SERVICE BULLETIN

No. 411A

Piper Aircraft Corporation

Subject: Stabilator Torque Tube Bearing Block Attachment Fitting Rivet Replacement

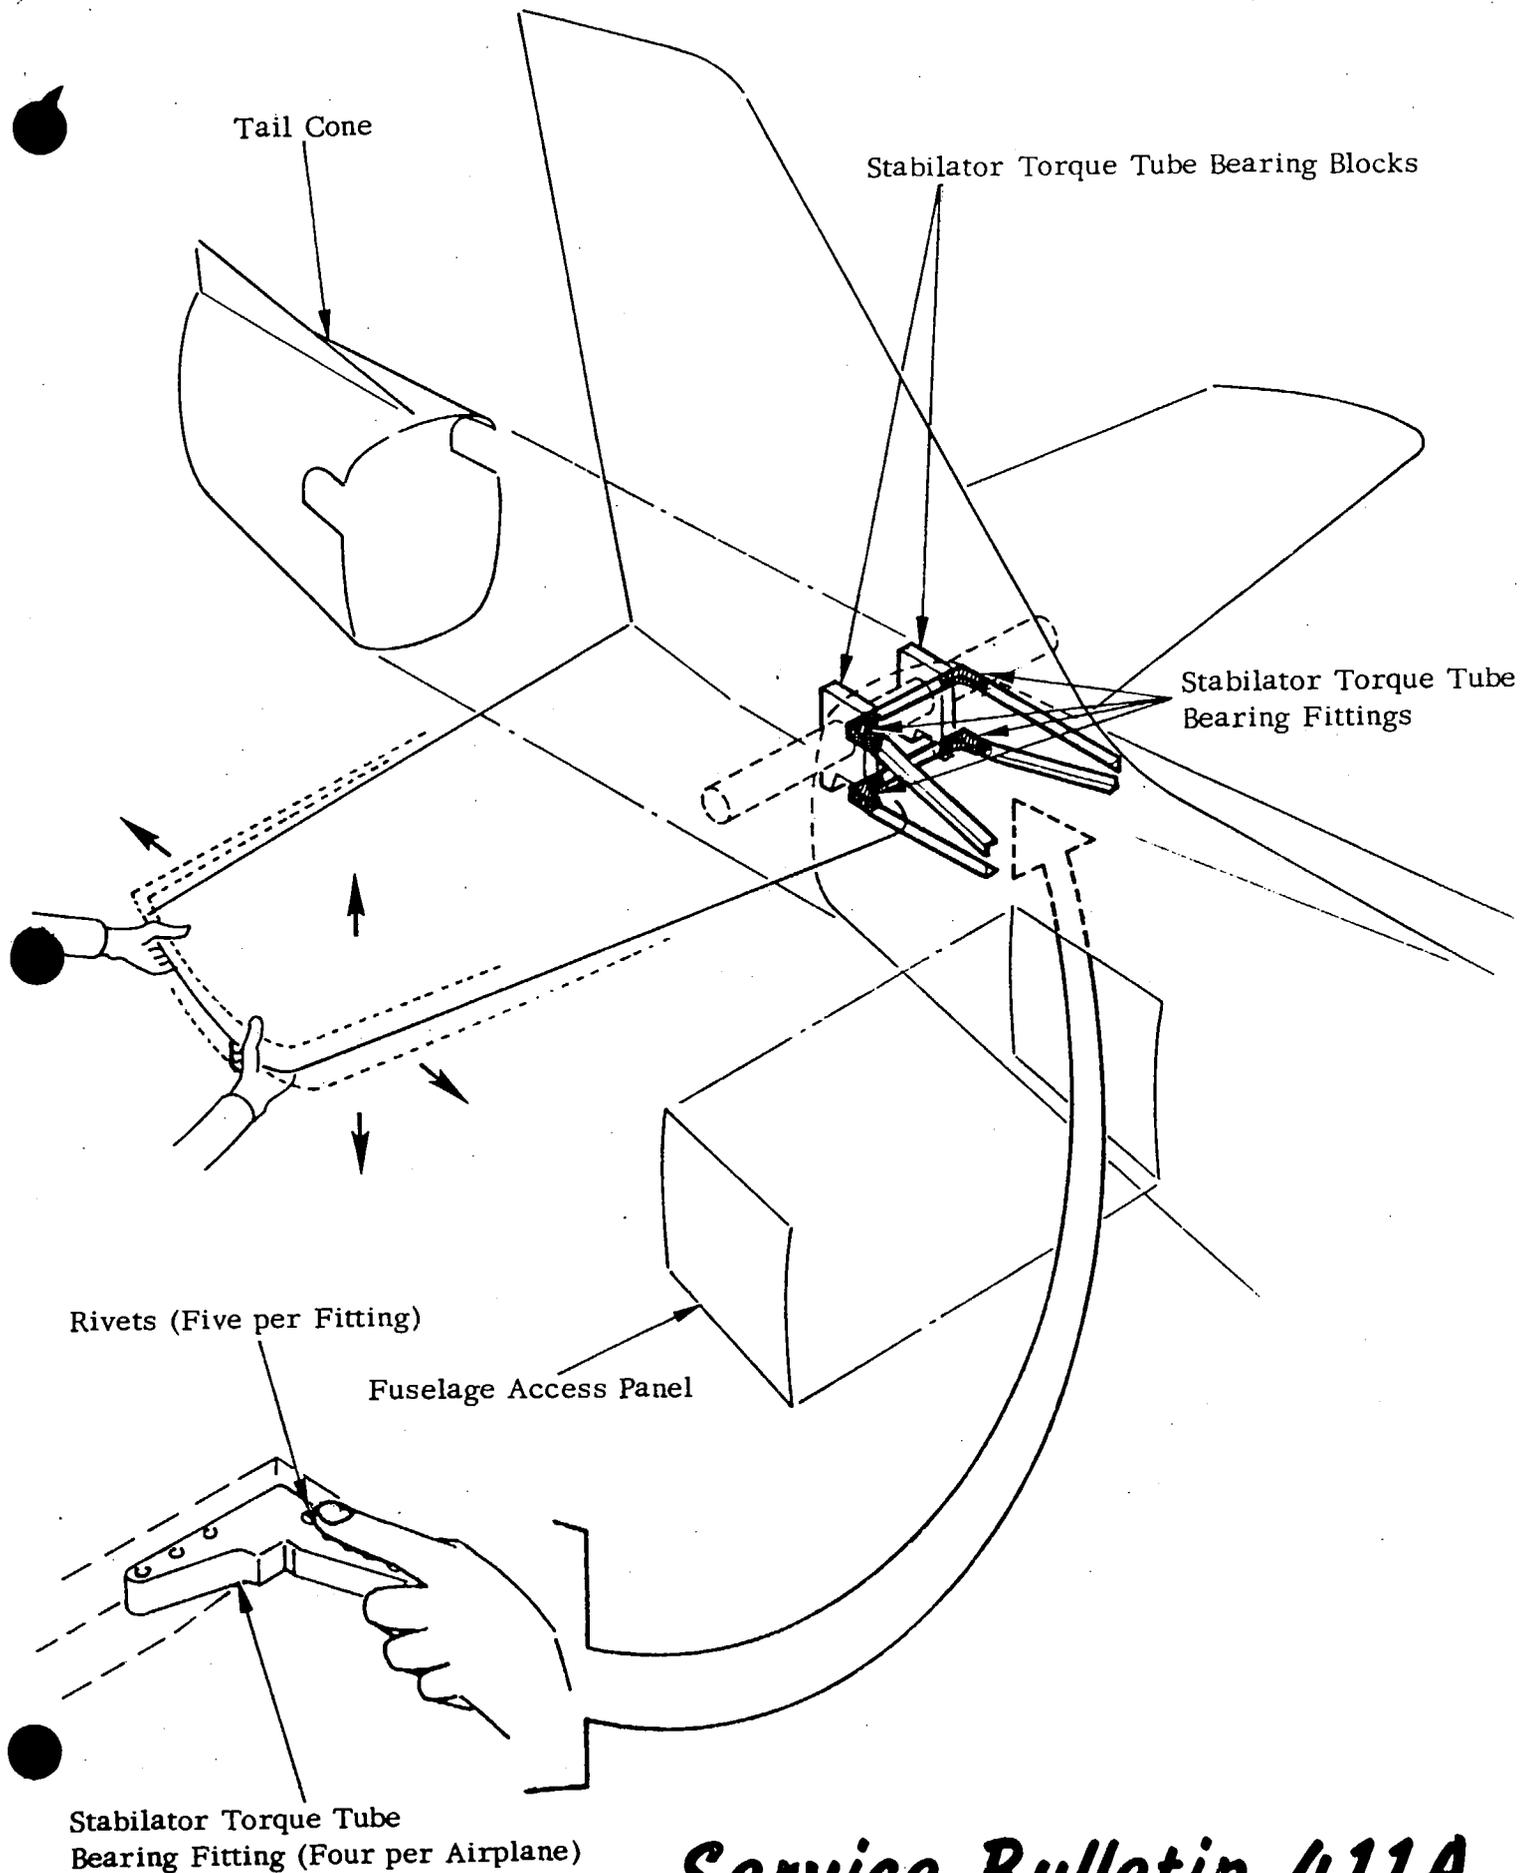
Purpose: Information has been received by the factory describing movement and/or noise in the area where the stabilator assembly joins the fuselage. It has been determined that the above described condition may have been caused by one of the following (refer to attached sketch for a pictorial description of the affected areas):

1. Stabilator torque tube bearings not firmly seated in the stabilator torque tube bearing blocks.
2. The holes in the stabilator torque tube bearing upper and lower fittings may be enlarged.

2. Simultaneously (with Step 1, above), have another person check closely for movement and/or noise in the area described in Purpose, above (the attached sketch illustrates a recommended method of detecting movement in the stabilator torque tube bearing fittings area).
3. If there are no indications of movement and/or noise, no further action is required (other than log book entry).
4. If there is movement and/or noise in the area described in Purpose, above, immediately contact the Customer Services Department, Piper Aircraft Corporation, Lock Haven, Pennsylvania 17745.
